Does 1166L
BNSF Need Plans?
~~Hal Industrial~~ Barnett Industrial
BNSF Conflict Sta 16620+00 WL

~~SECRET~~
BNSF Conflict No. 27 & 28

BNSF Conflict No. 55

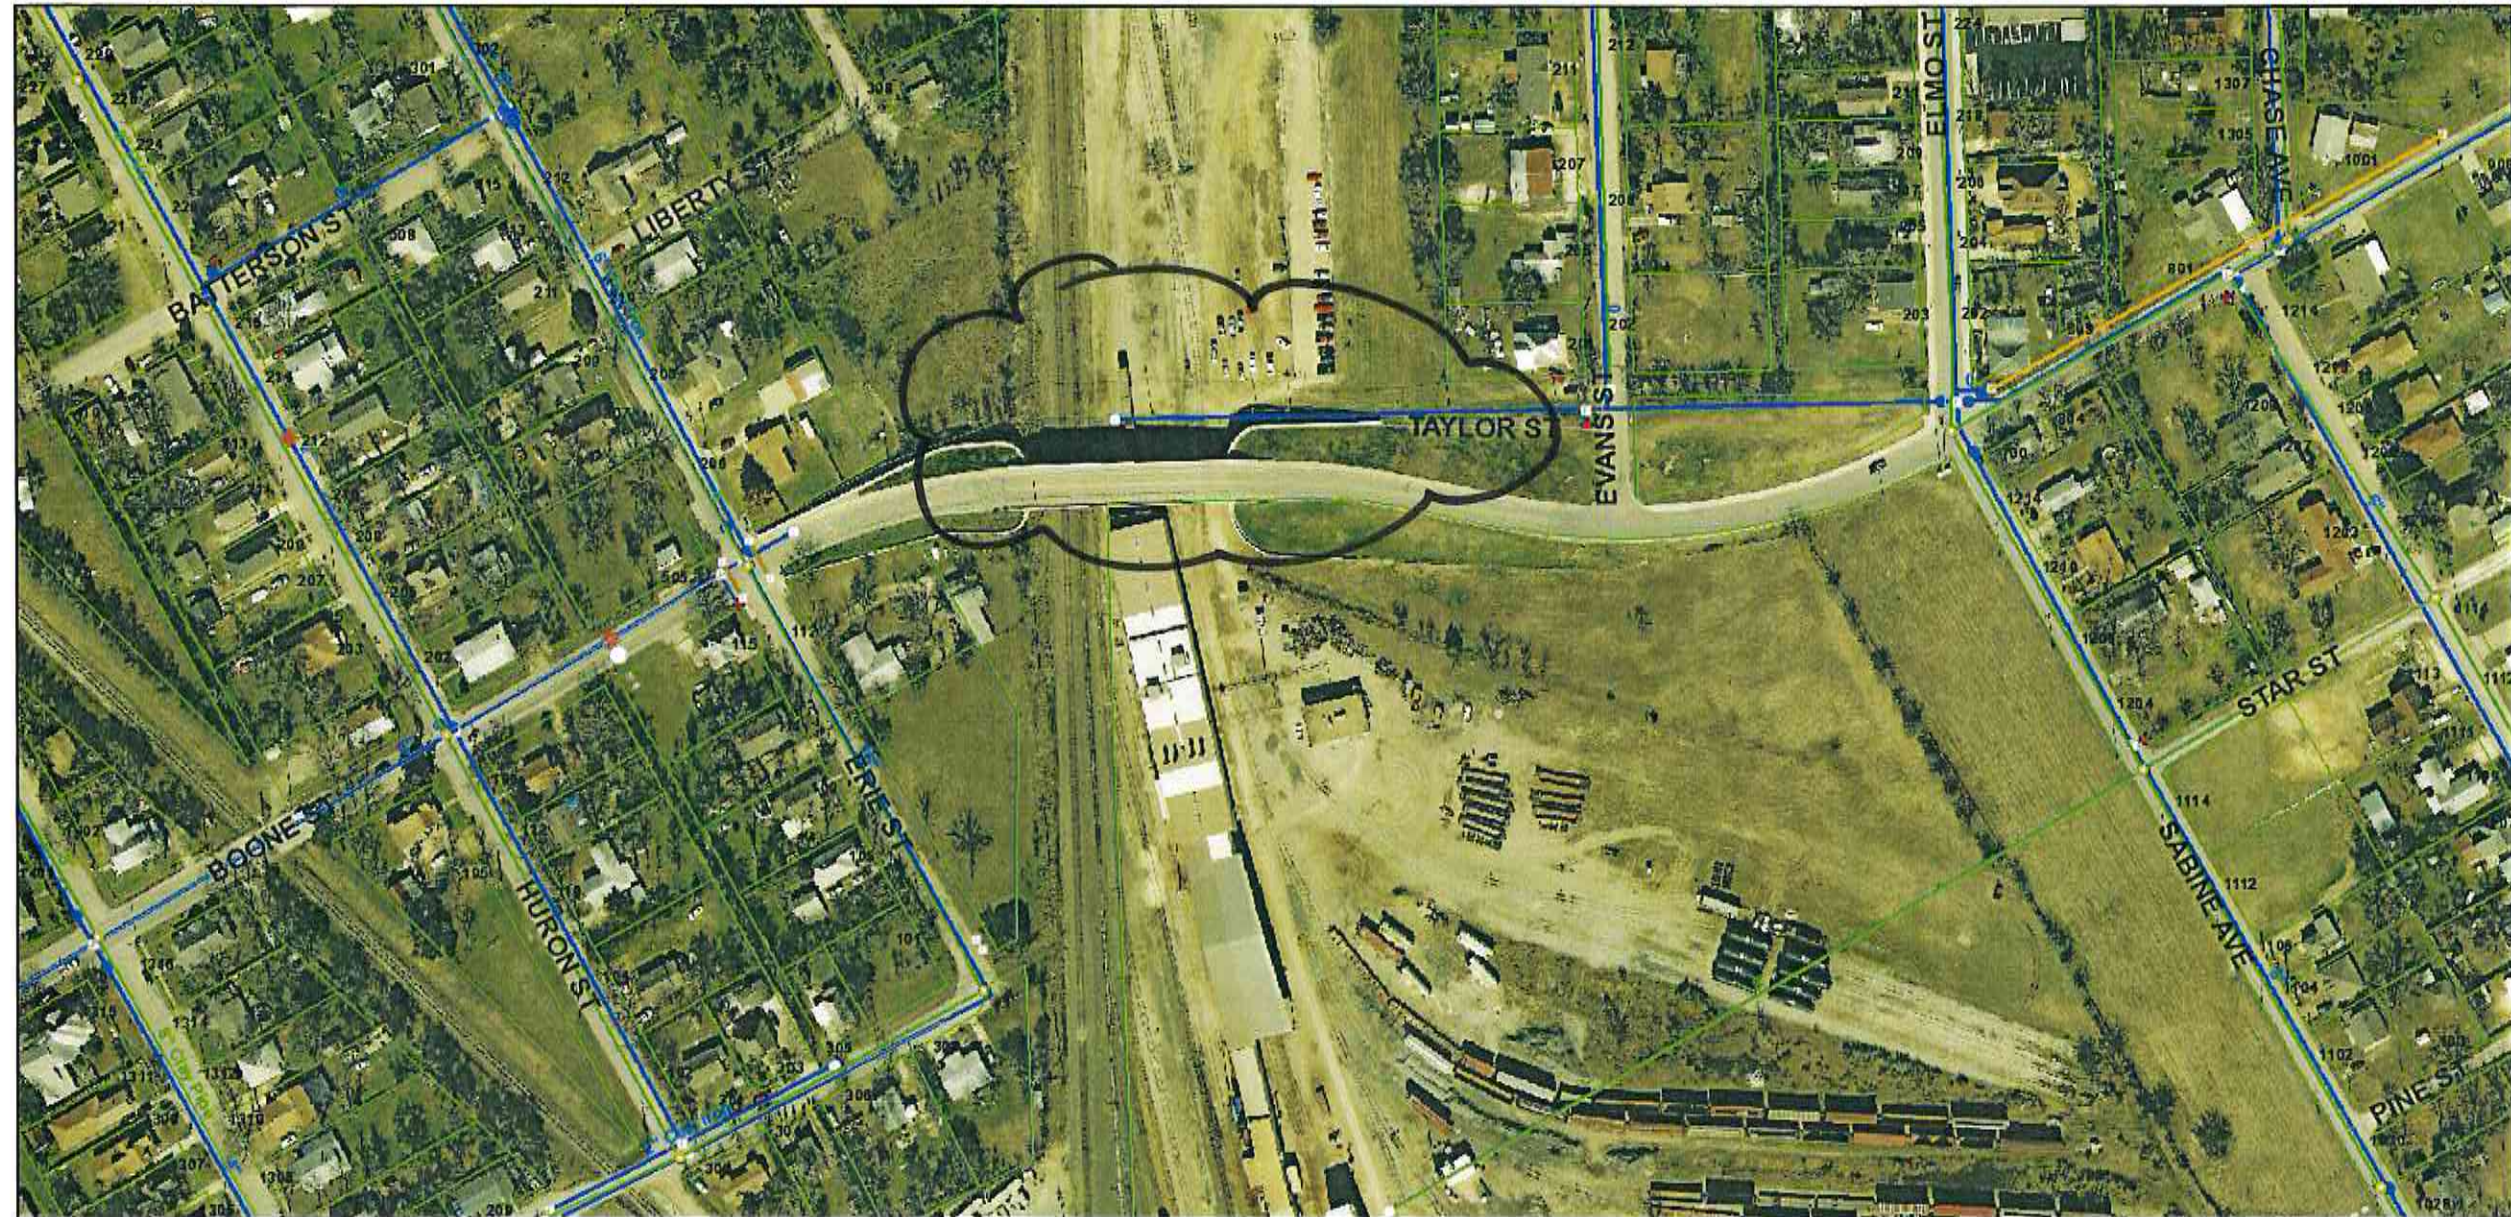
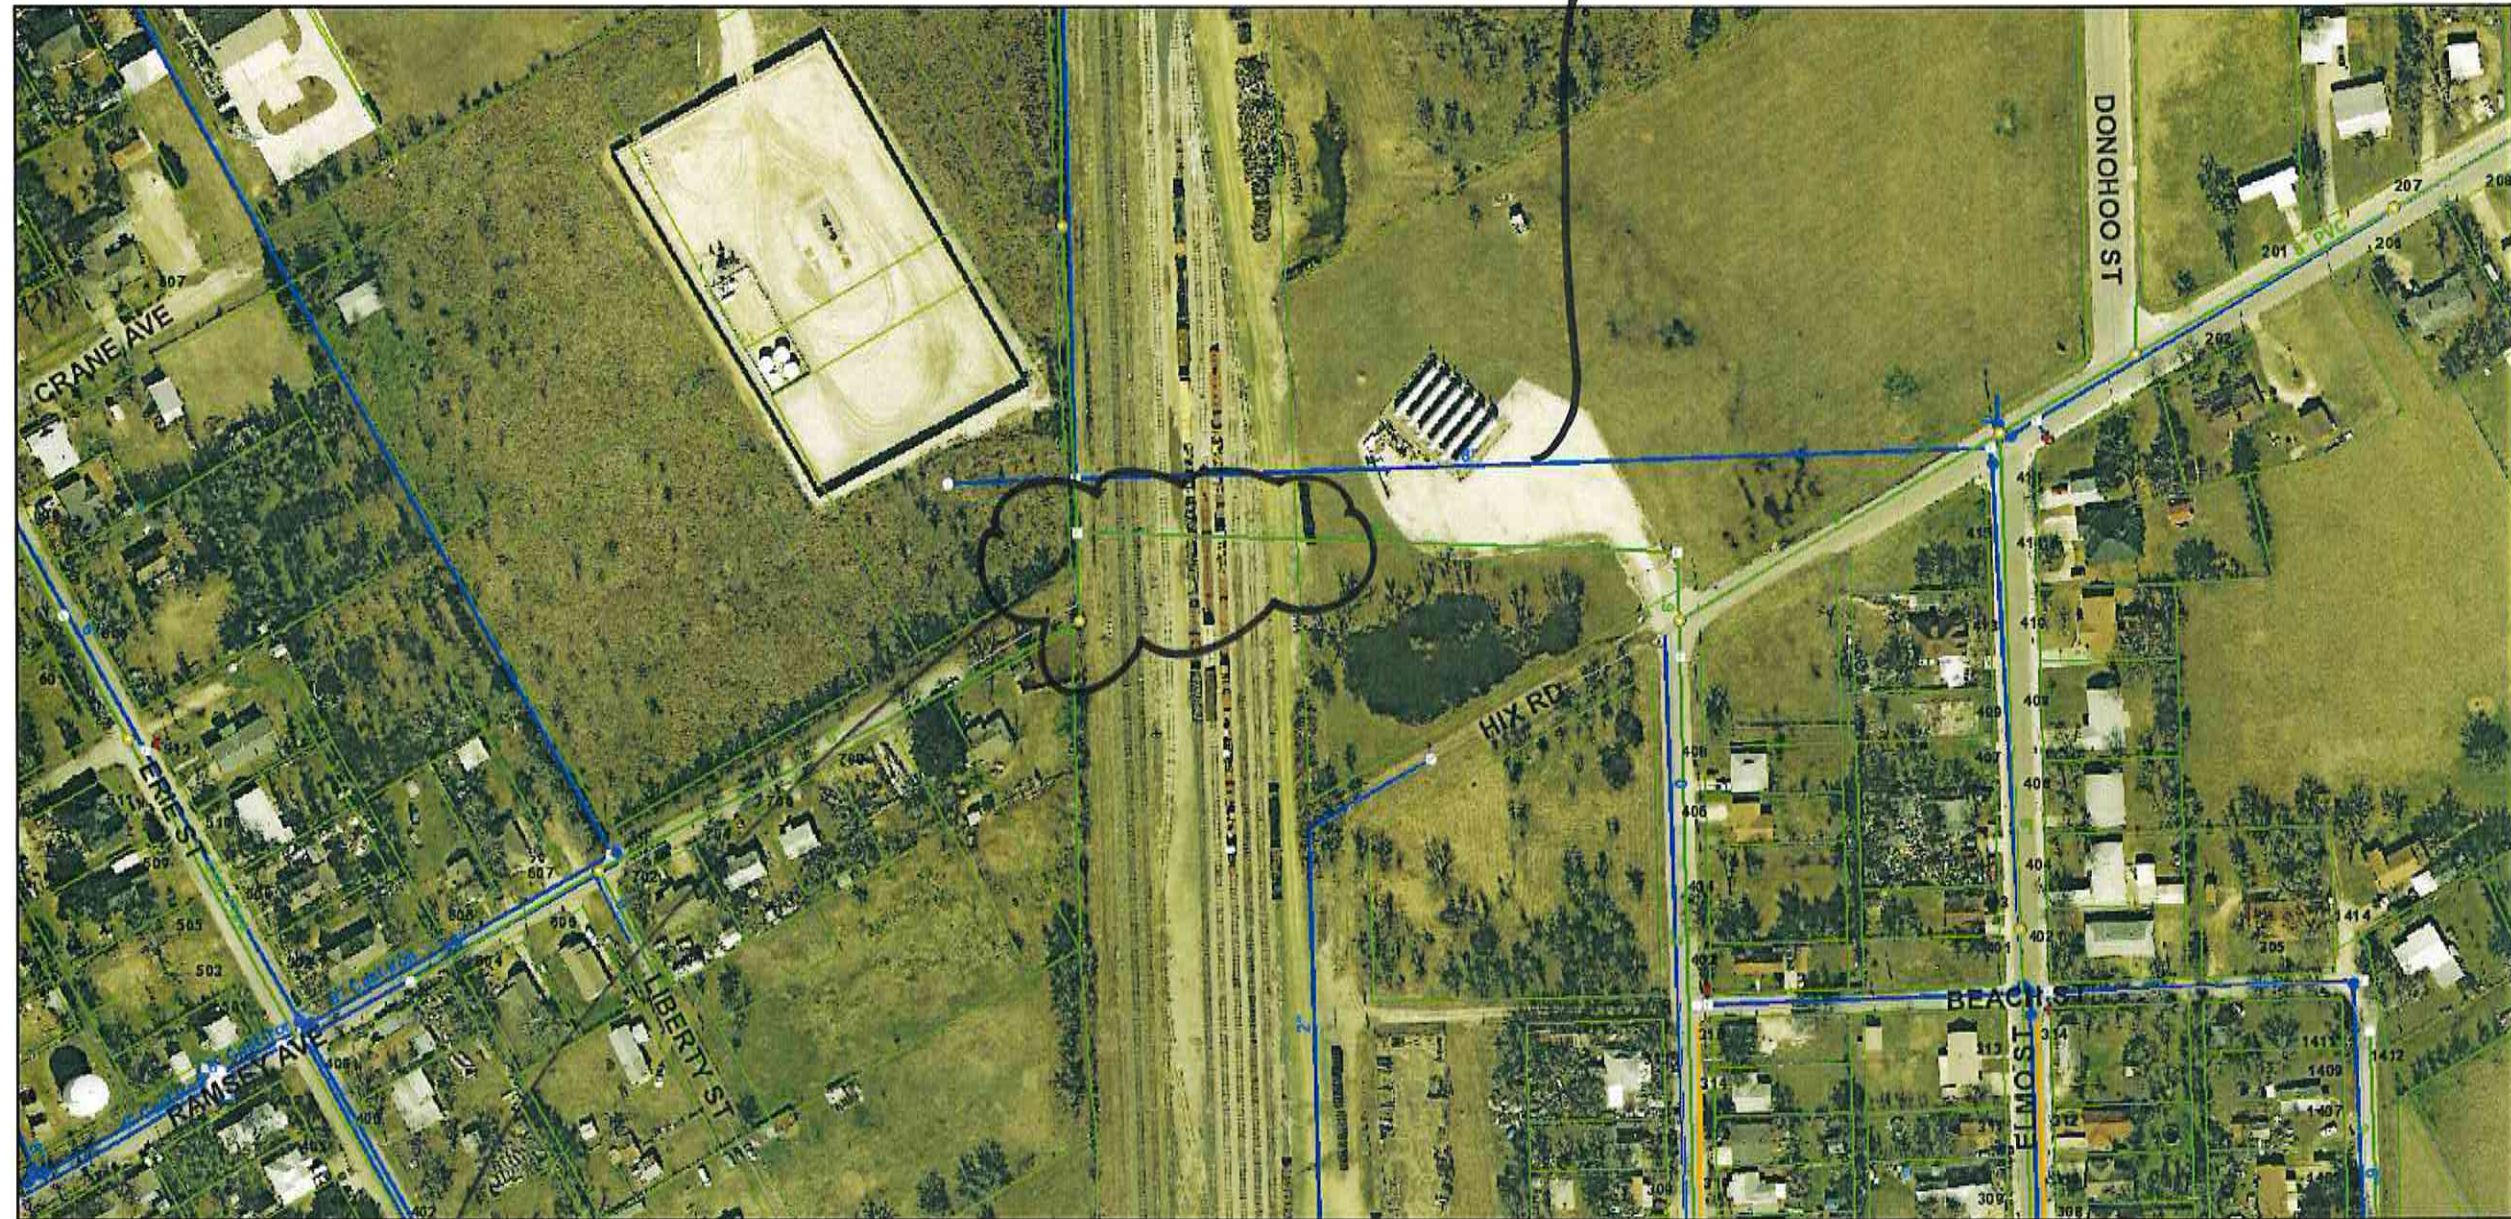
- alignment correct
- WL ends on east side of tracks

- no other water lines exist at this location
